NOTICE OF PUBLIC MEETING

Pursuant to Section 19.84, Wis. Stats., notice is hereby given to the public that the **Plan Commission** of the City of De Pere will meet on May 28, 2013 at 7:00 p.m. in the City Hall Council Chambers, Second Floor, City Hall, 335 South Broadway, De Pere, WI 54115.

Item #3: Review The Site Plan Application For A 39,060 Square Foot Building Expansion At Infinity Machine, 2249 American Boulevard. Applicant: Schuh Construction.

Item #4a: Review a Precise Implementation Plan (PIP) For Walgreens Located At The Northeast Corner of Broadway And Wisconsin. Applicant: Midland Development.

GENERAL PROJECT DATA & SITE PLAN

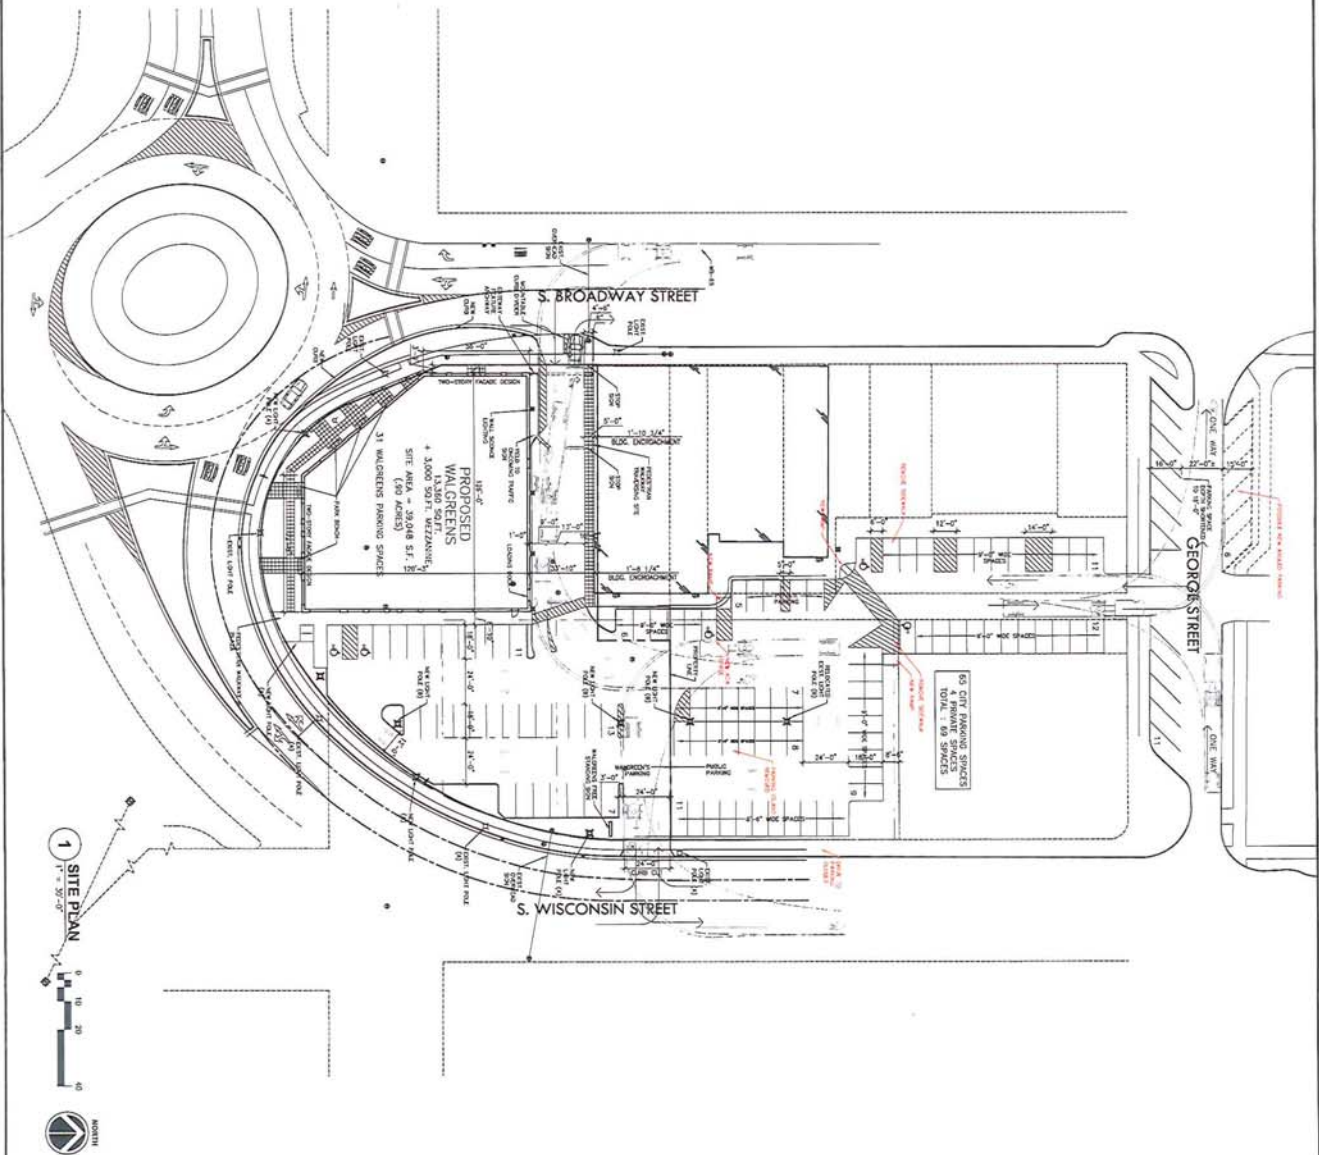
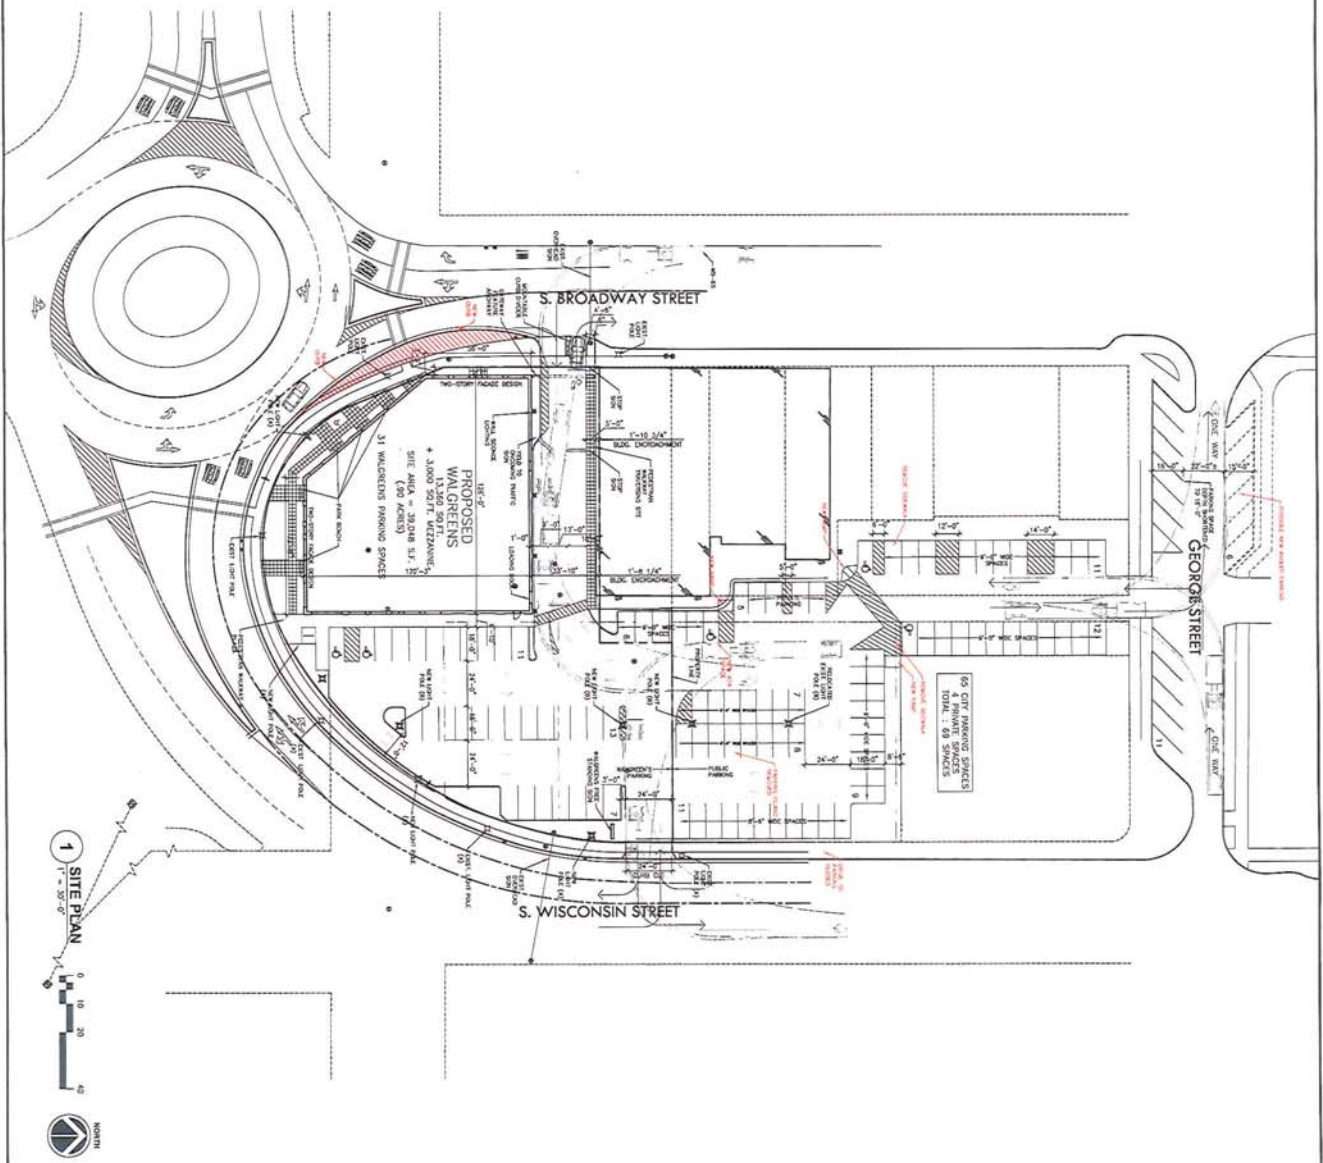
4. Coordinate utility relocations (gas, electric, telephone, etc.). **This appears to have started. Continue coordination.**
5. Light pole relocation/replacement will be required. **Provide a light plan.**

6. Clarify how the drive-thru window will operate on the north side of the building with traffic being directed westbound in the eastbound lane when utilizing the window. Is there going to be any signage or pavement marking to clarify this? **Completed.**

7. Add the street address to the plans. **Add the street address to all plan sheets.**
8. Add the soil boring locations to the plans. **Add the soil borings to the plans.**

9. **Final modifications to the curb at the roundabout will need to be approved by the City.**
10. **Verify that height of the arch in the driveway off of Broadway for clearance with semi-trucks.**

GRADING AND EROSION CONTROL PLAN
SOUTH WISCONSIN STREET & SOUTH BROADWAY STREET
WALGREENS
DE PERE, WISCONSIN

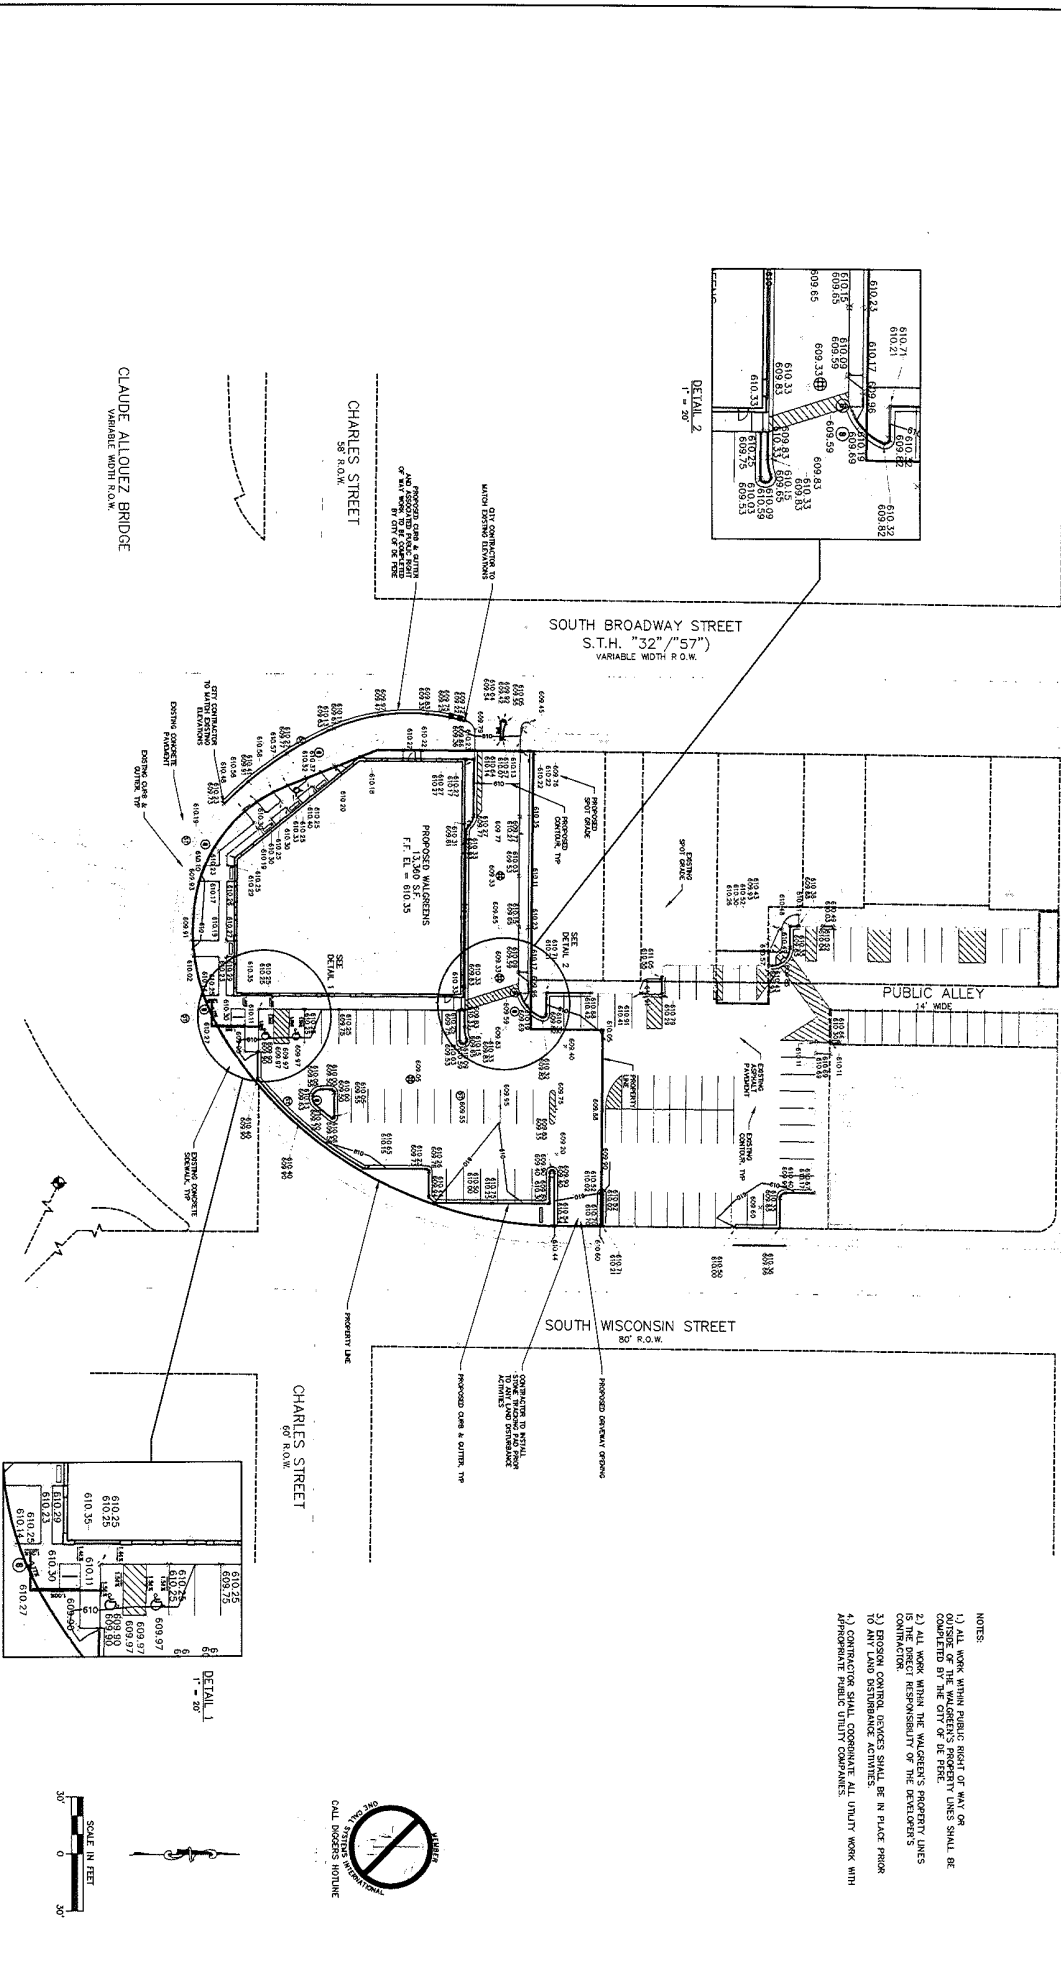
4. The total suspended solids (TSS) reduction from the site is to be designed for 40% removal from parking lot and roads to meet WDNR requirements.
 - a. **Revise the post construction drainage basins. The sidewalk on the south drains to City right-of-way and not the underground tank.**

PAVING AND UTILITY PLAN
SOUTH WISCONSIN STREET & SOUTH BROADWAY STREET
WALGREENS
DE PERE, WISCONSIN

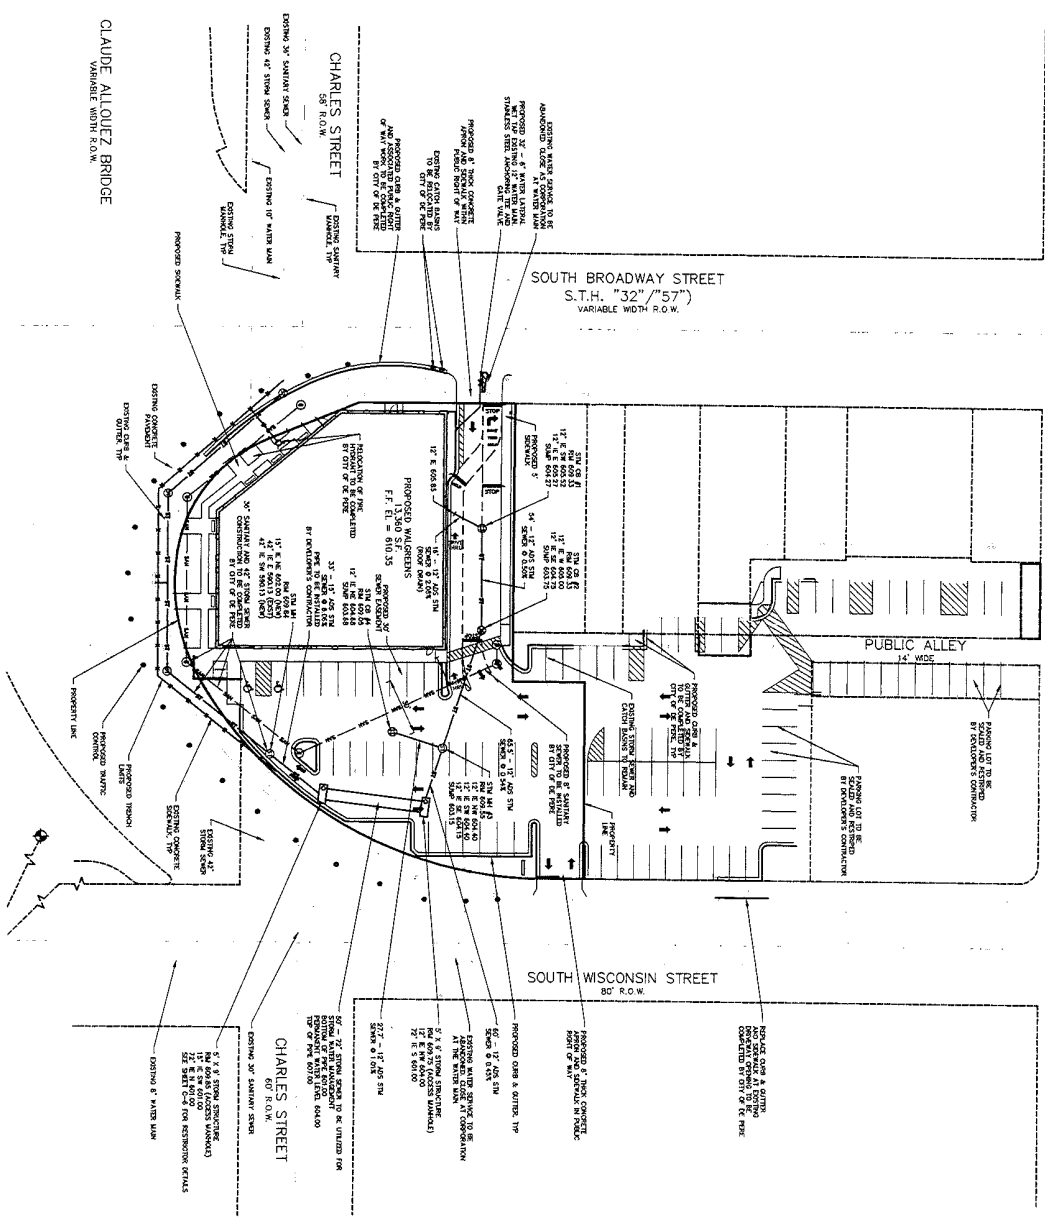
Water Main:	
<ol style="list-style-type: none"> 1. The hydrant and lead will need to be relaid due to sewer construction. This work is designed by the developer's engineer, bid by the City, constructed by the City's contractor, and funded by the developer. Completed. 2. All water services that are abandoned will need to be closed at the corporation at the water main. Completed. 3. Provide the location and size of the proposed water service. Completed.

1. All aprons are to be concrete. A minimum of an 8" concrete apron in the right-of-way and 8" thick sidewalk at the driveway is recommended. **Completed.**
2. Decorative sidewalk in the right-of-way is to be replaced in-kind. **Clarify this on the plans.**
3. Concrete panel replacement in the streets is to be done to an existing joint. All joints are to be doweled. Concrete and the base aggregate are to match the existing depths. **Show the anticipated limits.**

STORM SEWER PLAN & PROFILE

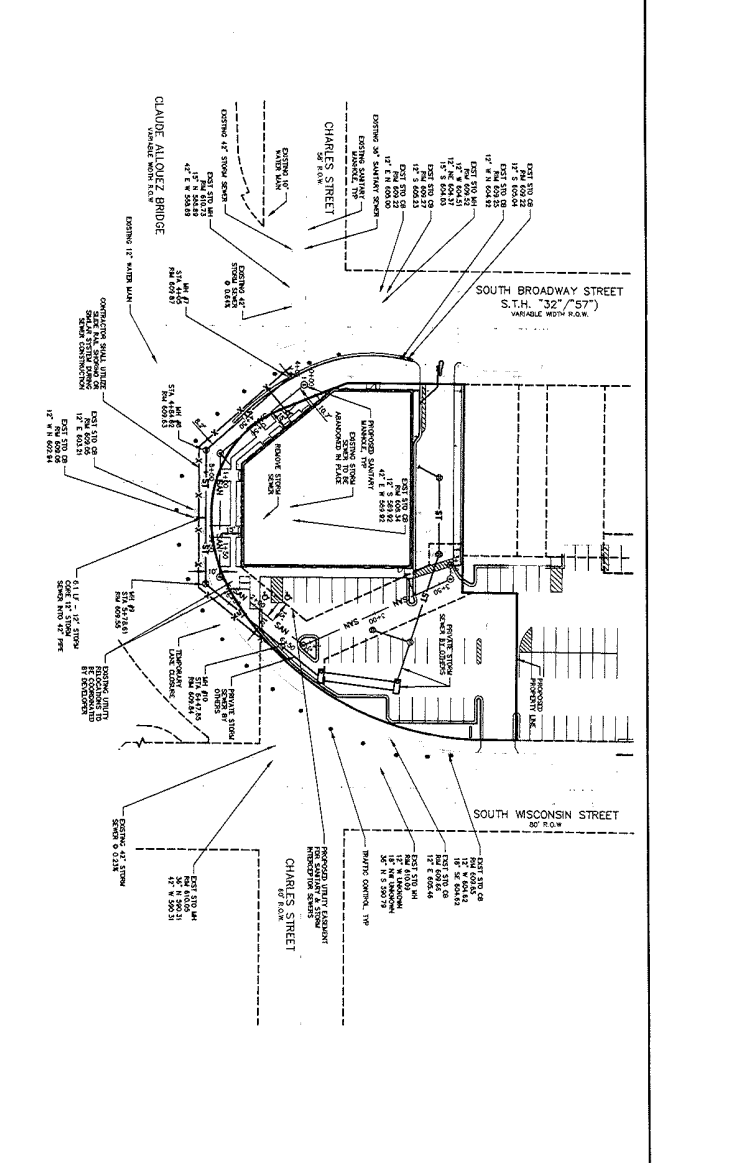
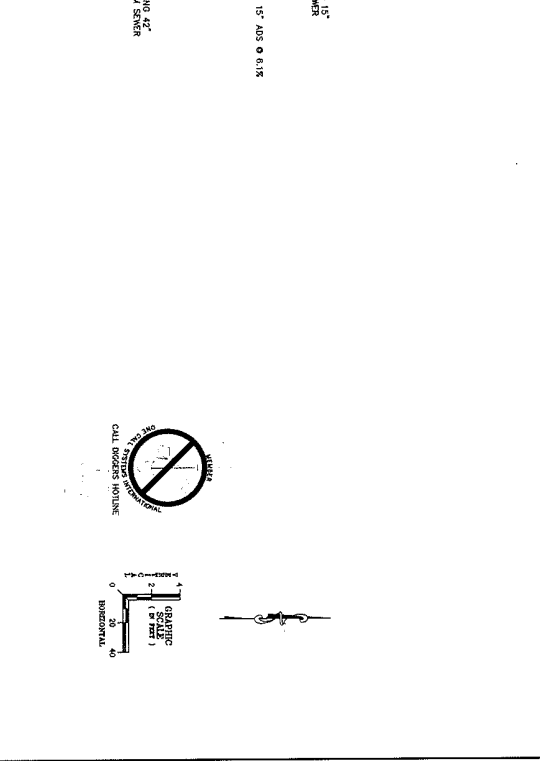
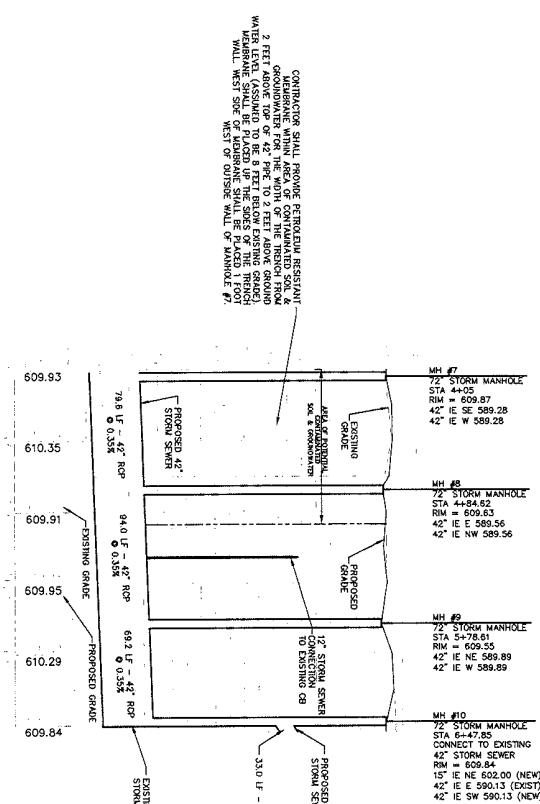
2. The soils report recommends significant undercutting of the soils for support under the 42" pipe (undercut 2 times the diameter) and a 3 foot over excavation on each side of the pipe. Based on this, a greater spacing is required between the outside edge of the pipe and the sheeting. Closure of northbound Broadway is anticipated. **The developer has indicated that they are going to perform additional soil borings. Any recommendations to address the poor soils need to be approved by a geotechnical engineer. Additionally, provide bedding recommendations from the geotechnical engineer. This comment also applies to the sanitary sewer.**

- b. **There is not enough information provided on WinSLAMM. The output sheets states the site as "Cemetery with no drainage system. The file should show the waste load generation based on roof, parking lot, green space, etc, with an area for each.**

- c. **Provide details/documentation that the structure has adequate detention times for settling solids.**
5. The post development peak flow cannot be greater than the pre-redevelopment peak flow of the site as it exists today. **Completed.**

7. Provide the location and size of the proposed storm sewer lateral. **Completed.**
8. Place a circular casting and cover on the storm manhole located in the curb line. **Completed.**
